# Process Sheet

DESIGN <i>CP</i>	DRAWN BY <i>CP</i>	DART AEROSPACE LTD HAWKESBURY, ONTARIO, CANADA	
CHECKED <i>[Signature]</i>	APPROVED <i>[Signature]</i>	DRAWING NO. DSI 9318	REV. A SHEET 1 OF 1
DATE 06.01.06		TITLE WASHER ADDITION	SCALE NTS
A	06.01.06	NEW ISSUE

# DART SERVICE INSTRUCTION

TO AMEND INSTALLATION INSTRUCTIONS D350-607 REV. F

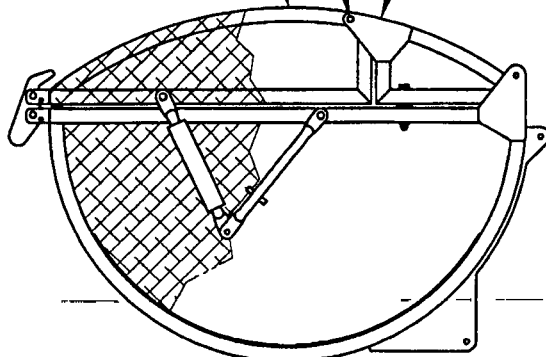
To reduce the possibility of damaging the finish, a **NAS1515H4** washer (2 places) has been added between the hinge plate and basket frame on the **D350-607-043/-047 Heli-Utility-Basket**.

The corrected bolt stackup from Figure 5 of installation instructions D350-607 Rev. F is given below:

AN4-13A BOLT (1)  
AN960JD416 WASHER (1)  
HINGE PLATE (REF)  
**NAS1515H4 WASHER (1)**  
BASKET FRAME (REF)  
AN960JD416 WASHER (1)  
MS21042L4 NUT (1)  
(2 PLACES)
